TOWNSHIP 27 NORTH, RANGE 72 WEST, OF THE SIXTH PRINCIPAL MERIDIAN, WYOMING.

SUPPLEMENTAL PLAT

This supplemental plat showing corrected bearing and updated lottings and areas is based on the plat approved April 27, 1938.

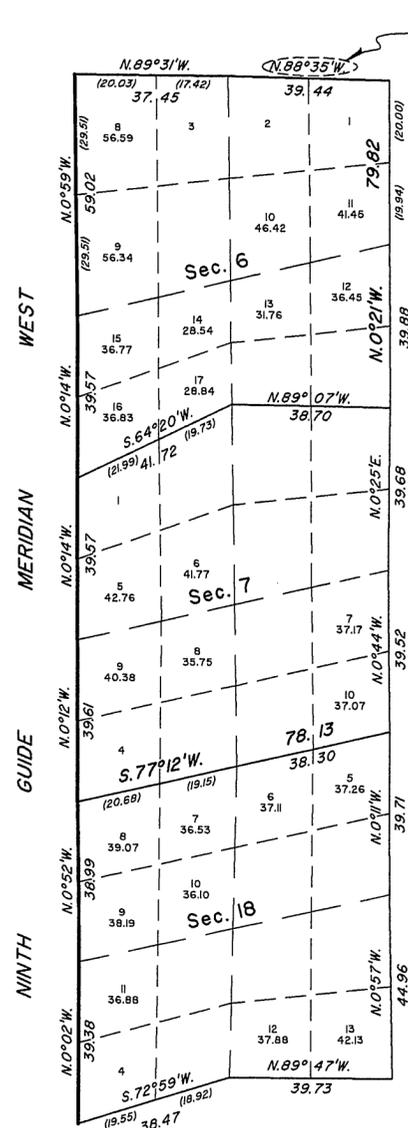
NOTE: A conflict was found in the official records of the 1937 resurvey pertaining to the bearing of this line. The plat returned a bearing of N.89°35'W., while the field notes returned a bearing of N.88°35'W. It was determined from calculations used to close the section that the N.88°35'W. bearing was correct.
